BEFORE THE HEARING COMMISSIONERS

of a subdivision to create 242 residential lots within the C2 Growth Cell, and associated lots for public assets by 3MS of Cambridge GP Limited (SP/0179/20)

STATEMENT OF EVIDENCE OF JIMMY JIENAN ZHUANG (Urban Design)

Dated: 18 May 2021

| UD0001 | A |

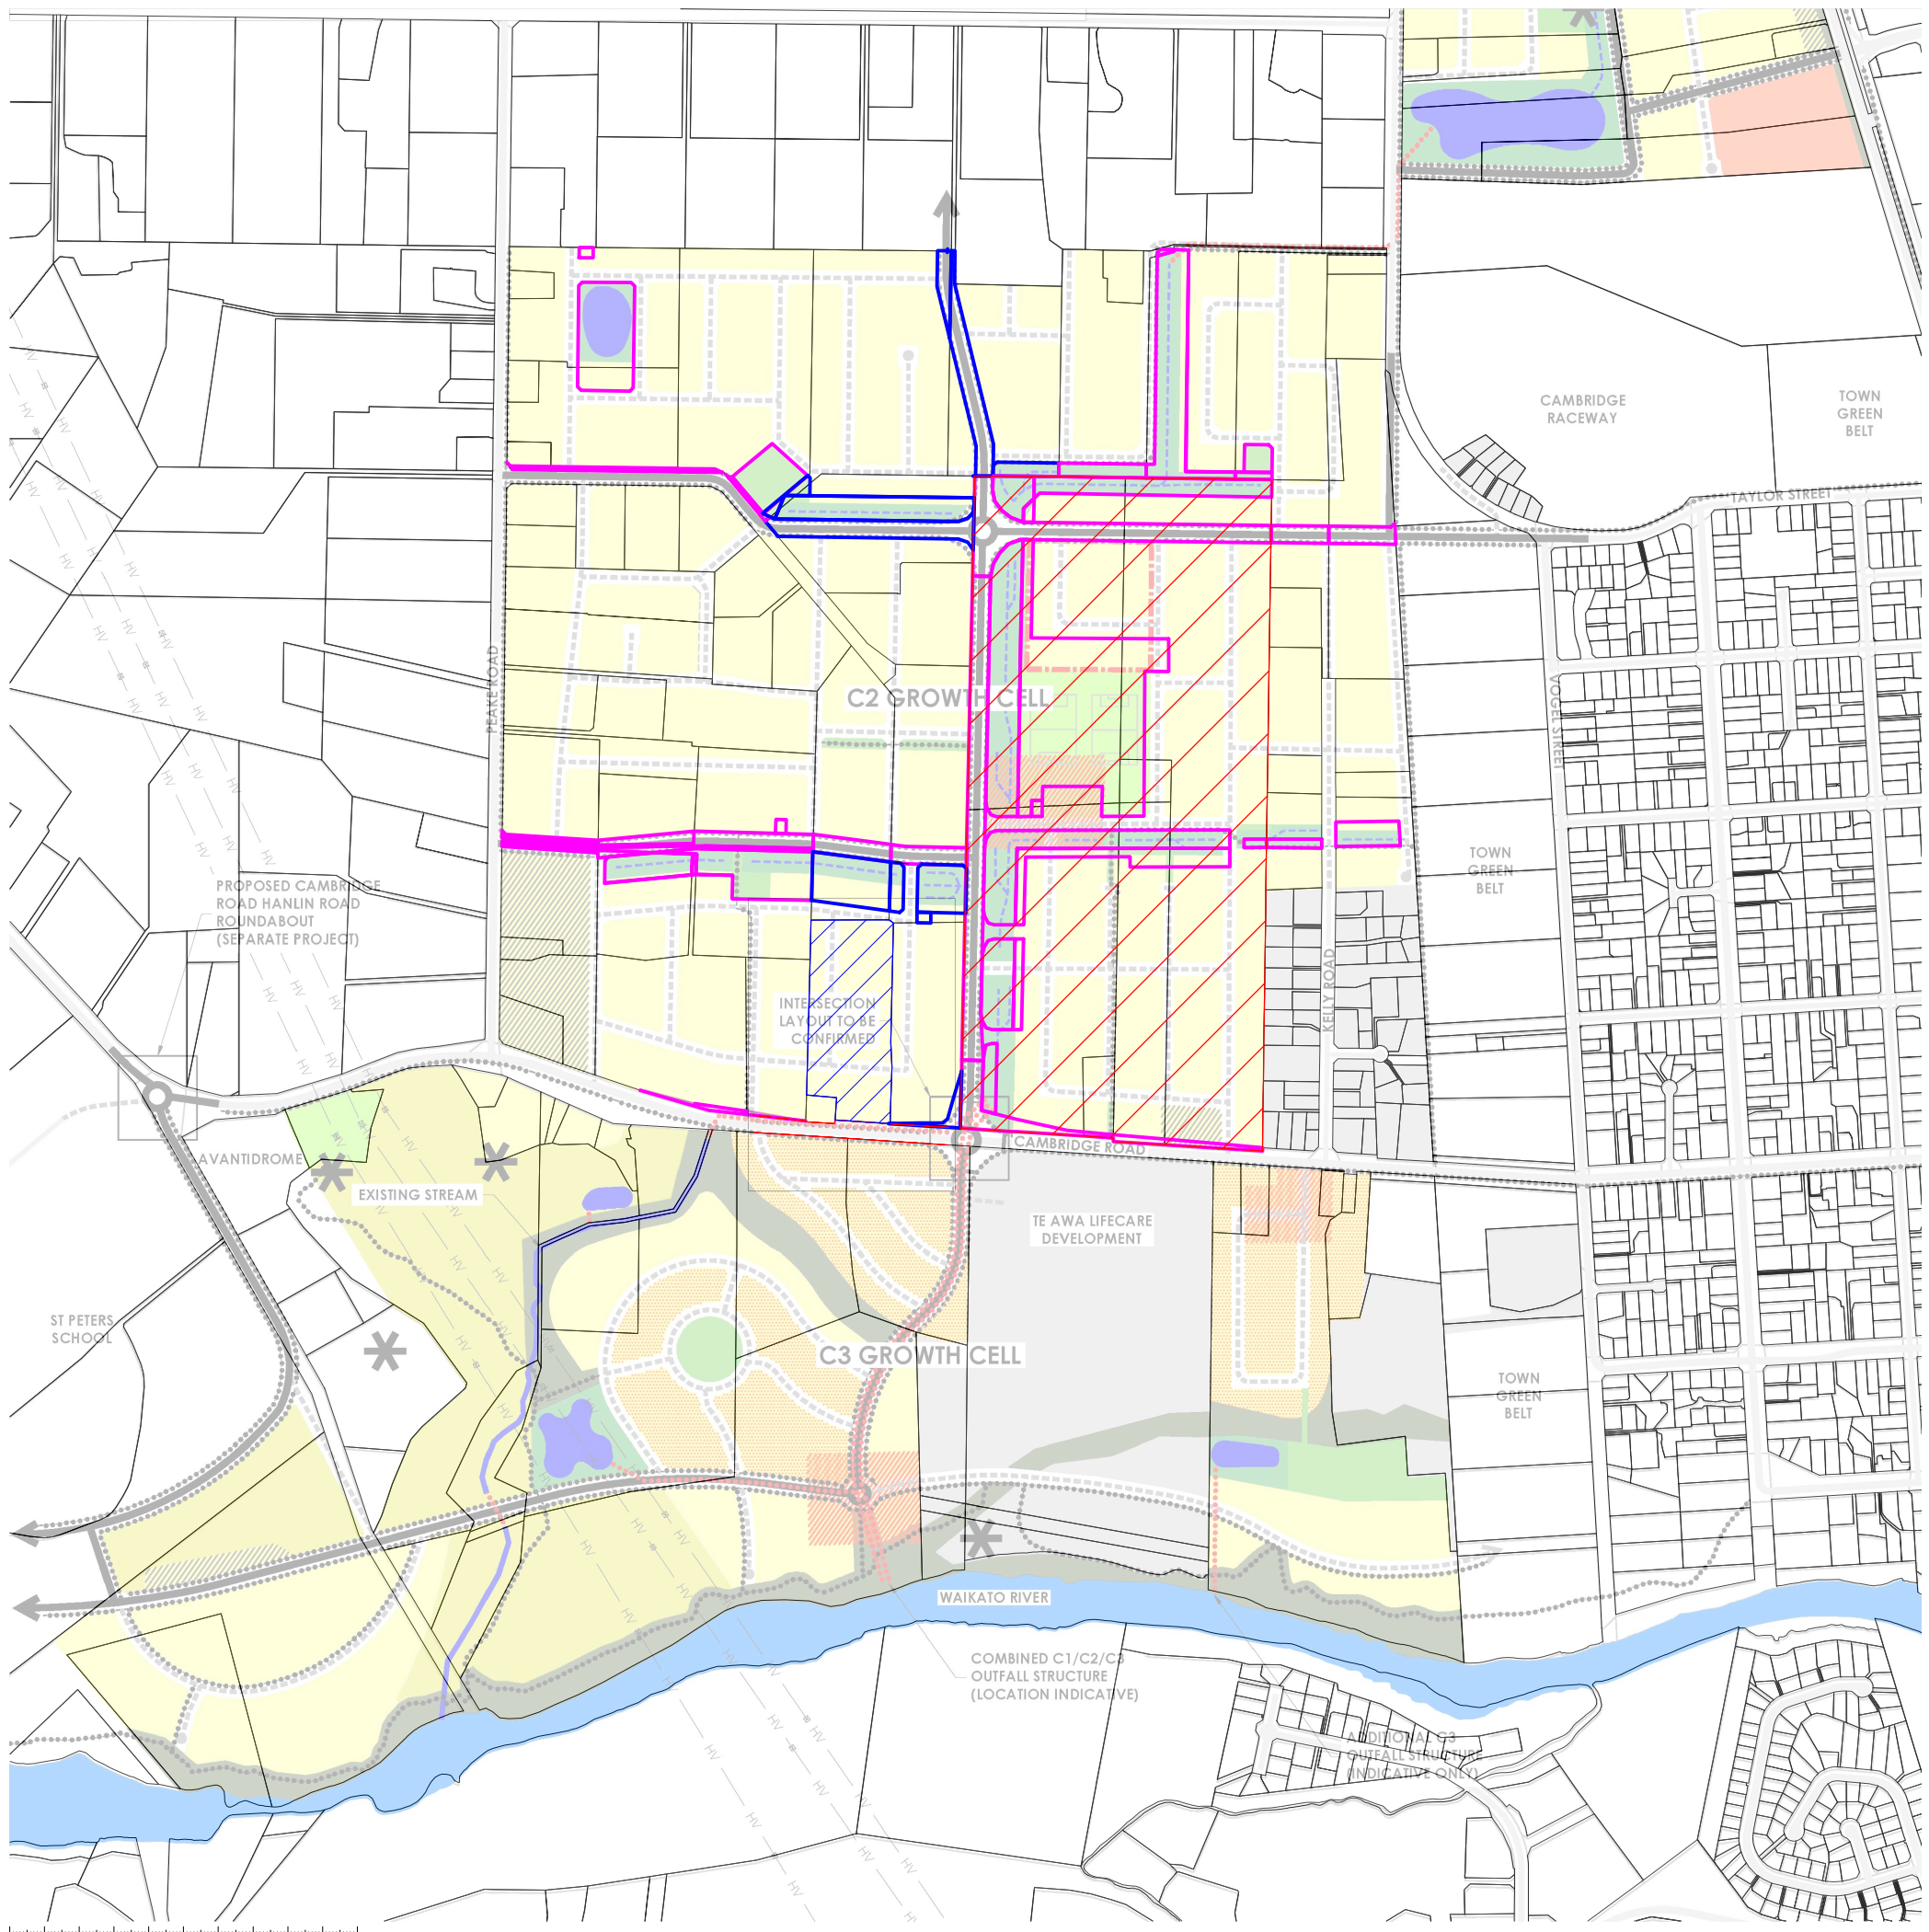
- c. significant reduction in street frontage to Cambridge Road (refer to **Drawings – UD0001, UD0002, UD0101, UD0102**); and
 - d. insufficient distance from the roundabout for Cambridge Road and Collector Road.

- 5.15. WDC's District Plan – Structure Plan currently shows no land required for the Collector Road and Open Channel Space (refer to Drawings – **UD0001, UD0002**) in Submitter 4's land. I have prepared a rationalised and hypothetical street-block plan (**Drawing – UD0002**) to show one of a few scenarios of how the Submitter 4's land could be designed in accordance with the Structure Plan.

UD0002 A

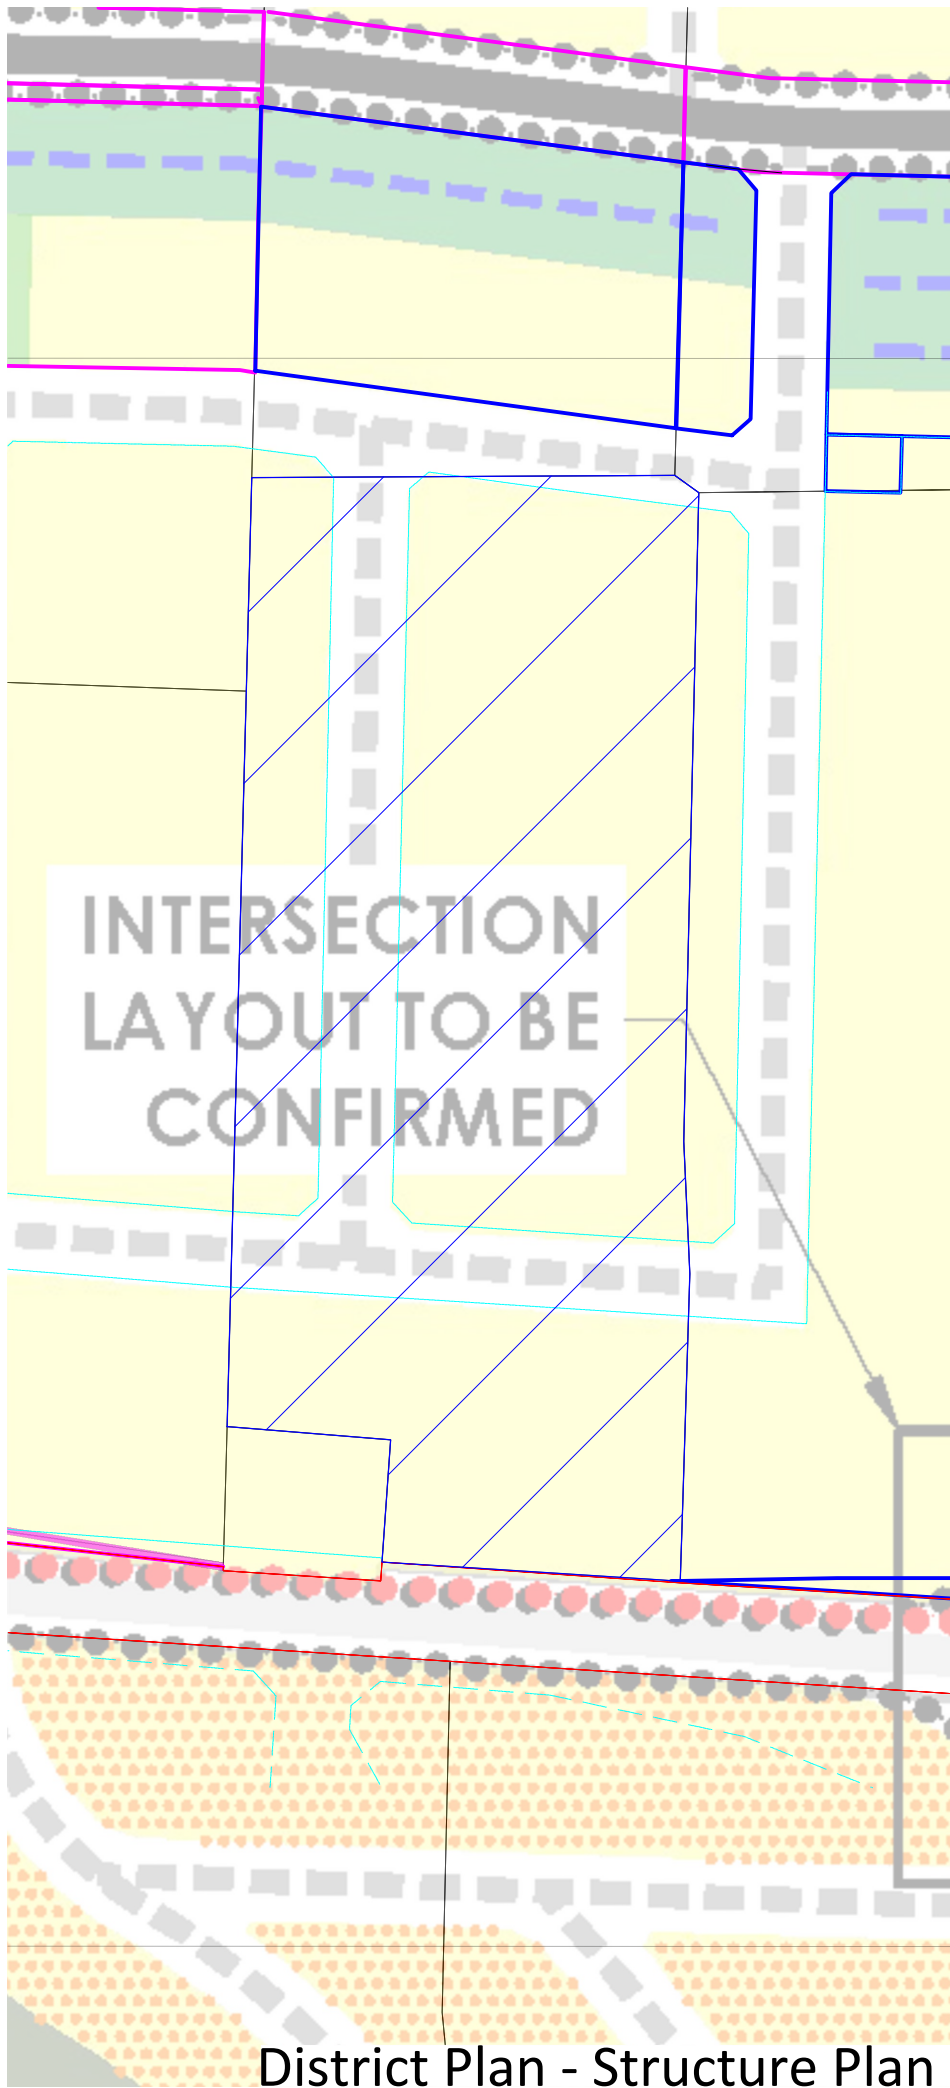
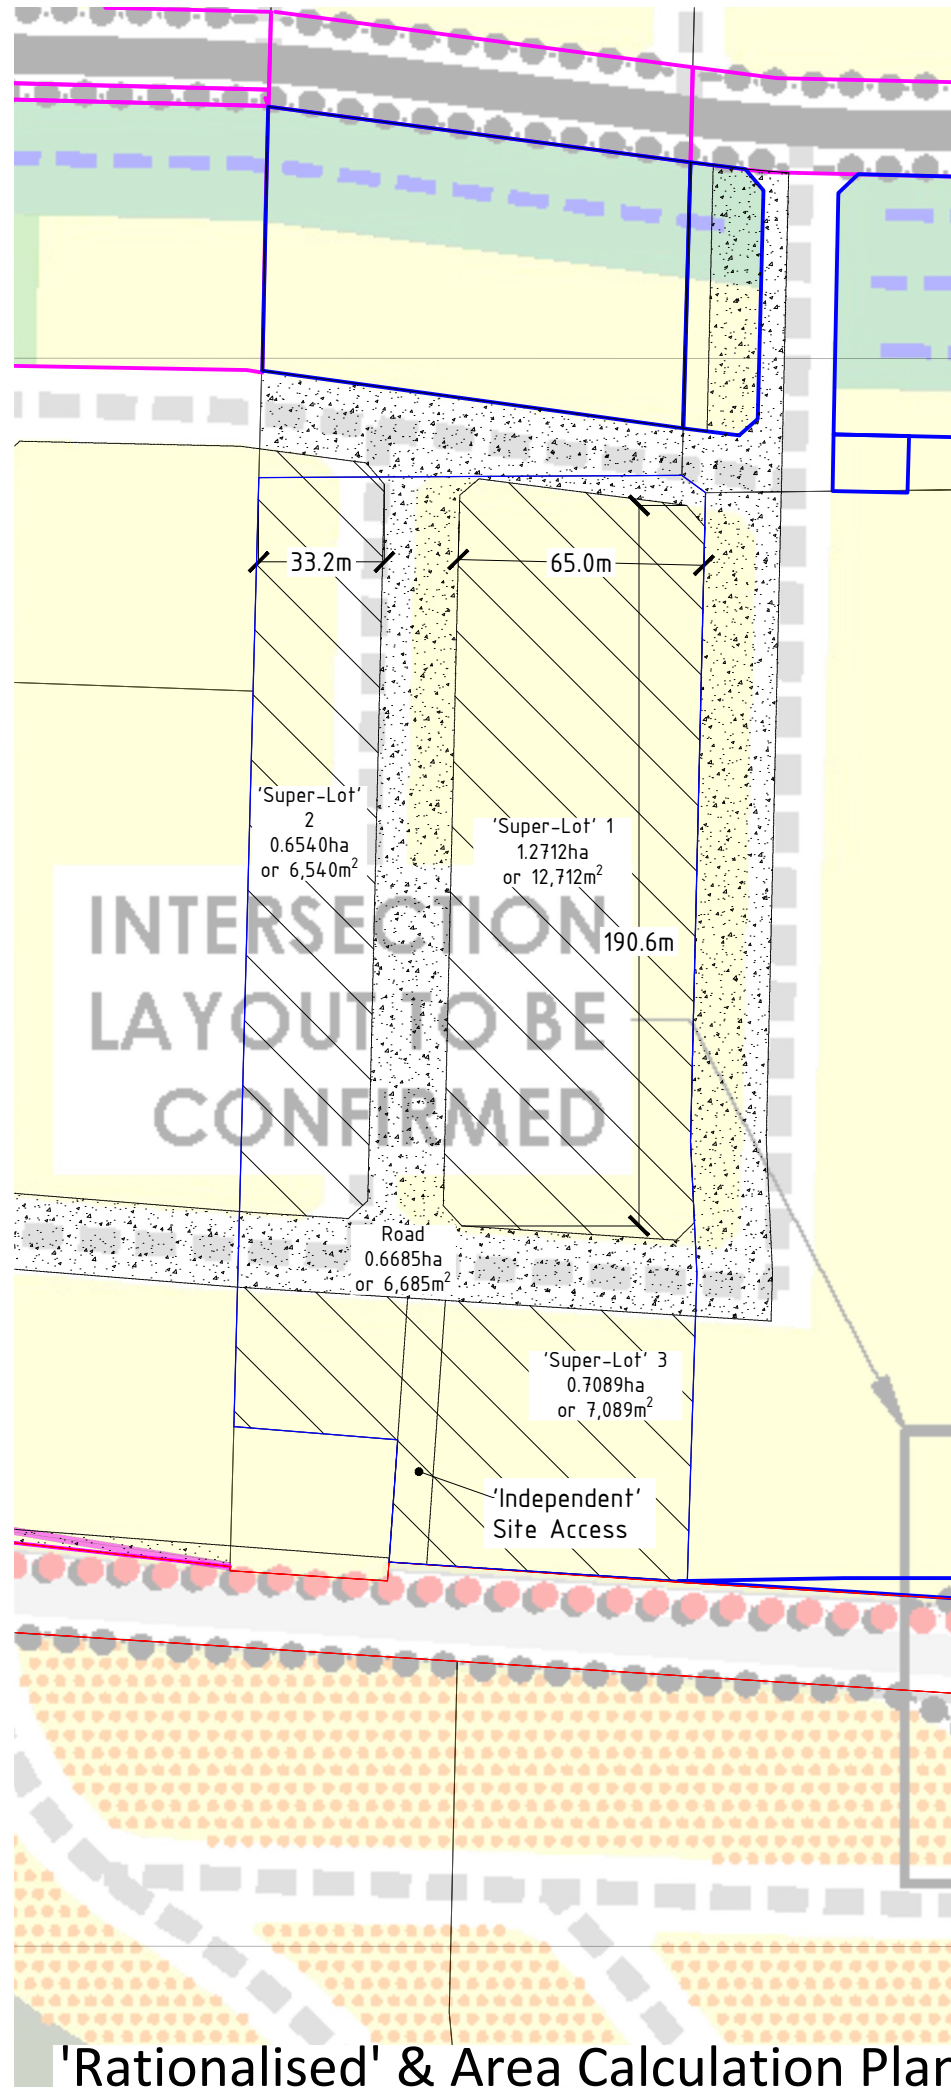
- 5.16. Based on the Structure Plan, I relocate a local road slightly towards and along the eastern boundary of Submitter 4's land. In doing so, there would not be any redundant land left on the western side of the local road for 1835A Cambridge Road. A north-south local road is proposed in a location/spacing where a double lot-depth ('Super-Lot' 1 in **Drawing – UD0002**) and a single lot-depth half street-block ('Super-Lot' 2 in **Drawing – UD0002**). This arrangement ensures that individual lots will achieve one of the most fundamental urban design principles – having their own public frontages and private backyards.

- 5.17. The placement of the roundabout for the Collector Road and Cambridge Road in the Structure Plan, particularly the splay of the lot boundaries, is sufficiently far away from Submitter 4's land. Such placement should allow Submitter 4's land to retain an independent access regardless the site will or will not be developed. If Submitter 4's land and surrounding properties are fully developed, such access could be closed and developed for residential allotments.
